STEWART BUILDERS LLC

Permit No: PRRES20212466

Project Address: 508 SE DAVID RD, LEES SUMMIT, MO 64082

BY _____ STRUCTURAL REVIEW
HD ENGINEERING & DESIGN
DATE _____ HD: 41202 DATE: 5/20/2021

MAIN LEVEL - B

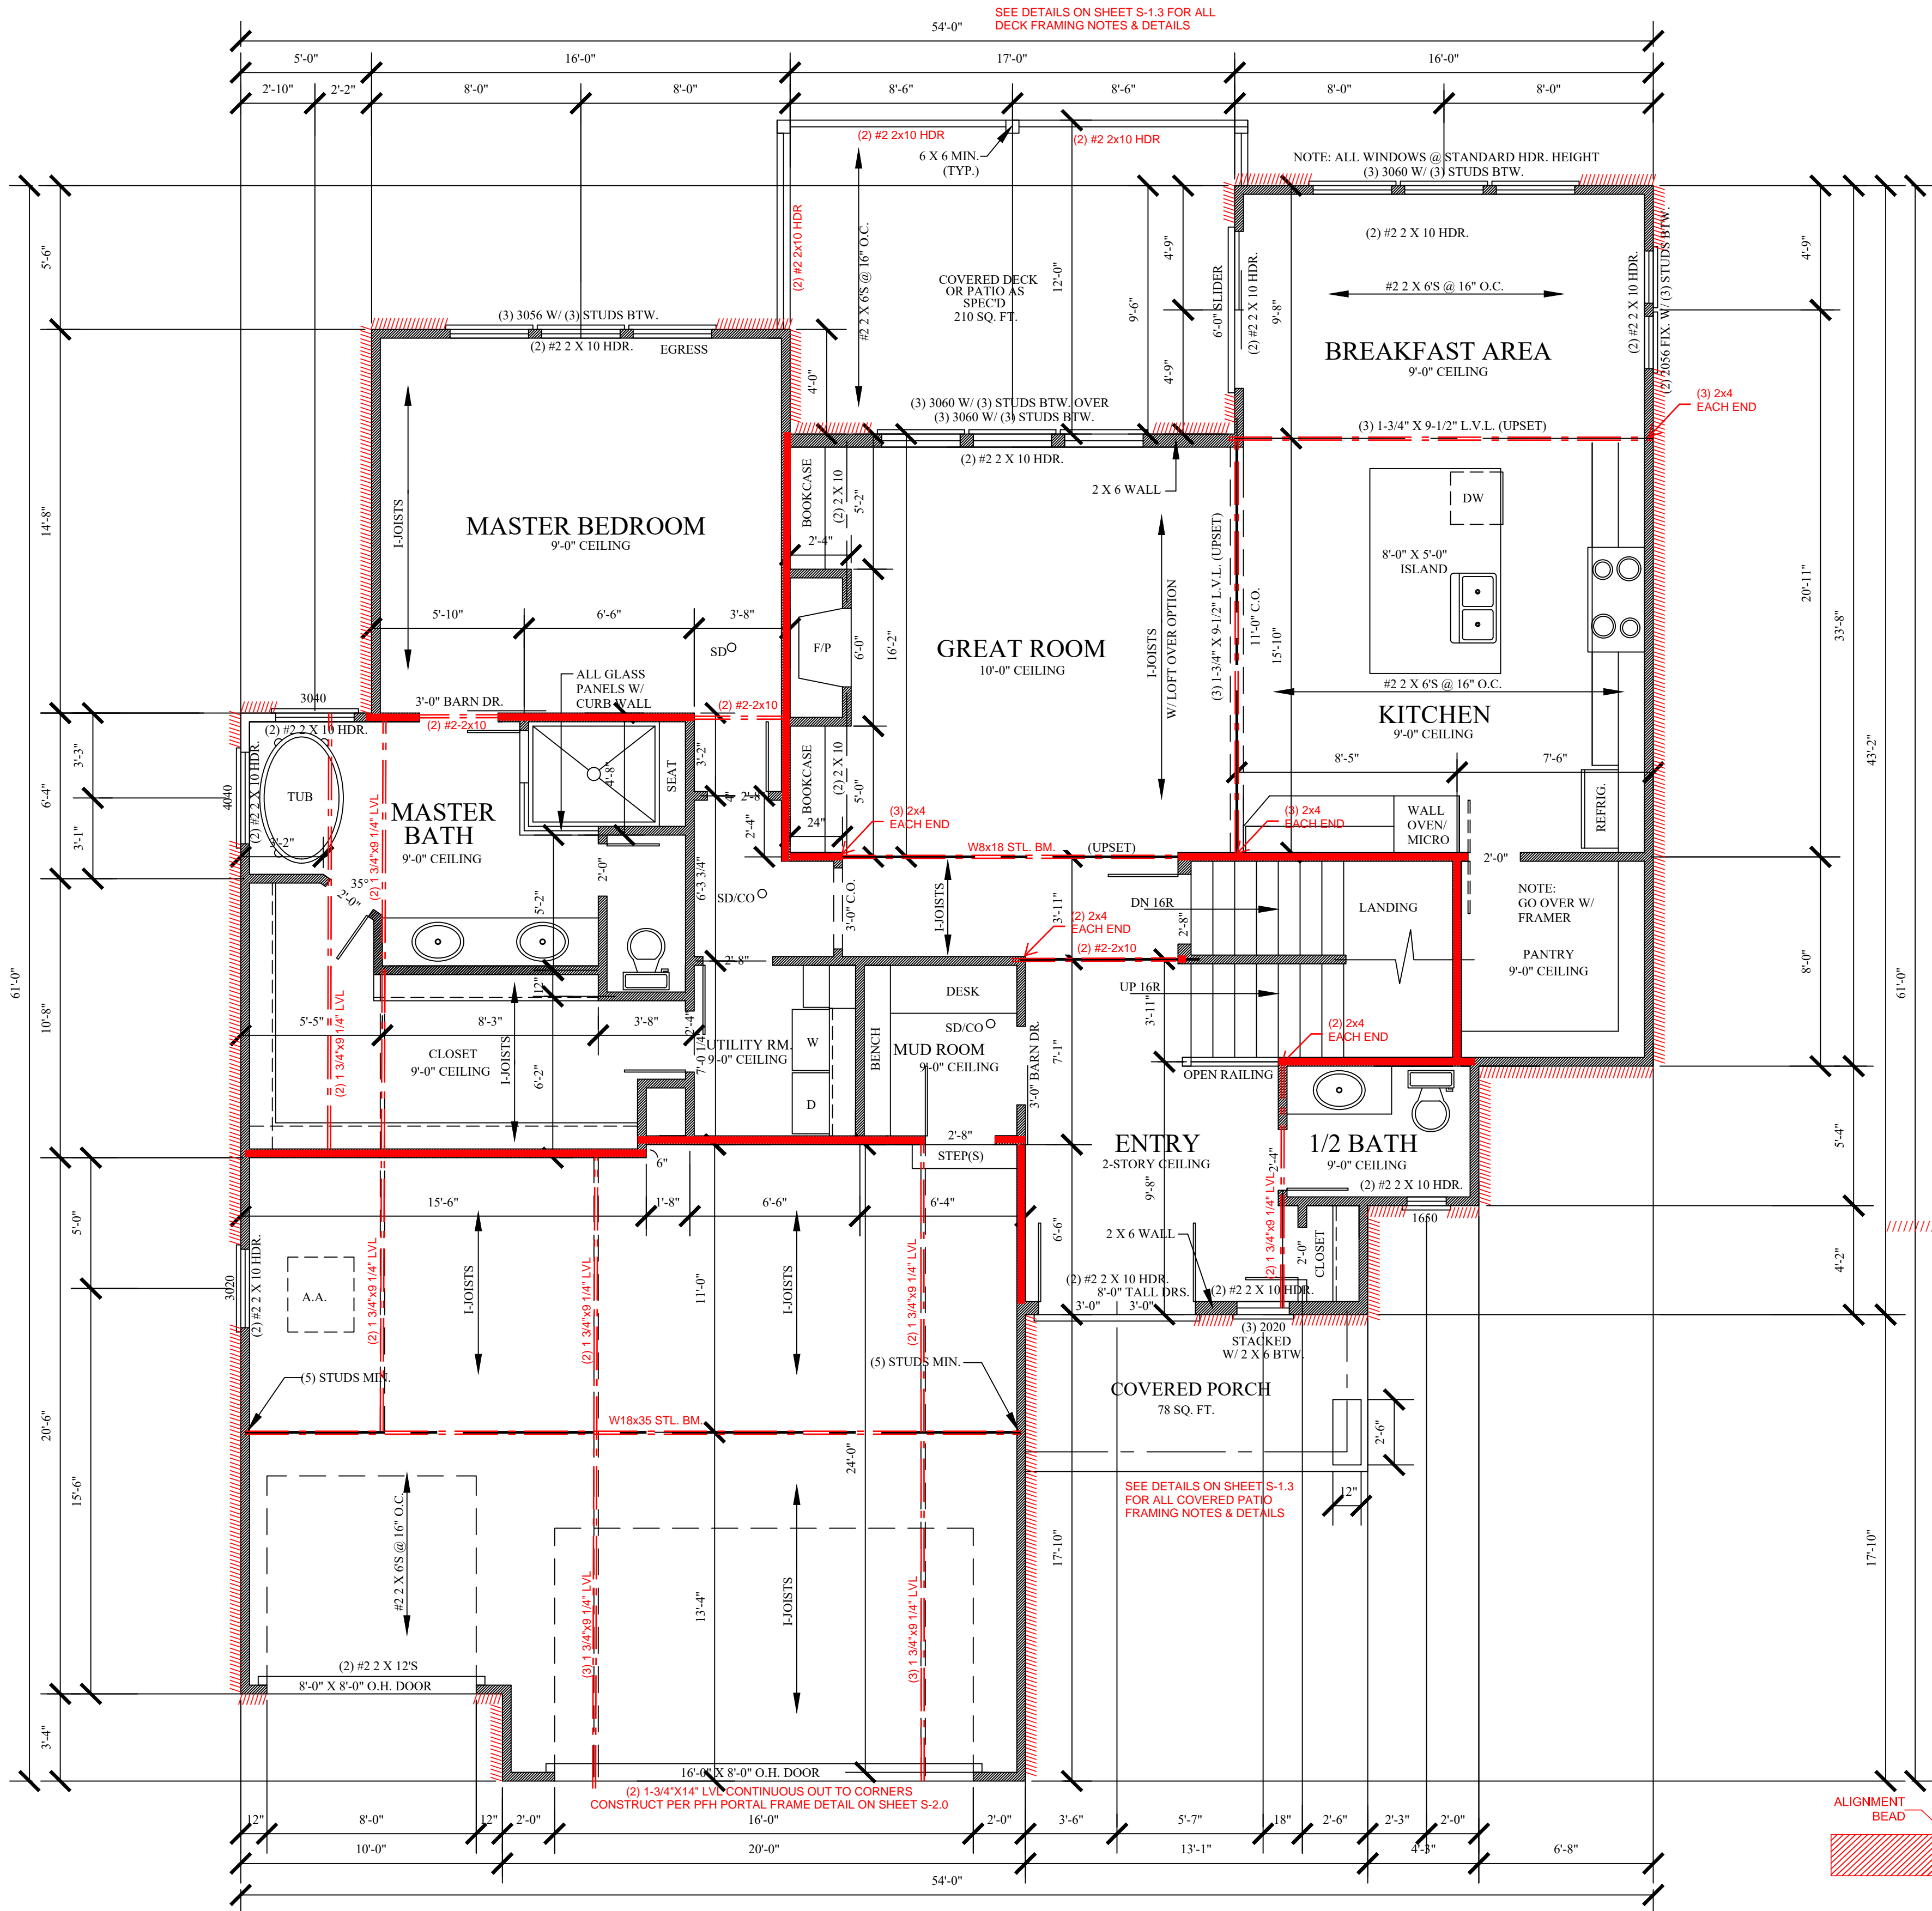
2. Provide square footage of living area, garage area, unfinished basement area, etc (IRC Section R304) no garage sq. ft.

SEE CLOUDED REVISED SHEET 4.

GARAGE - 645 SF
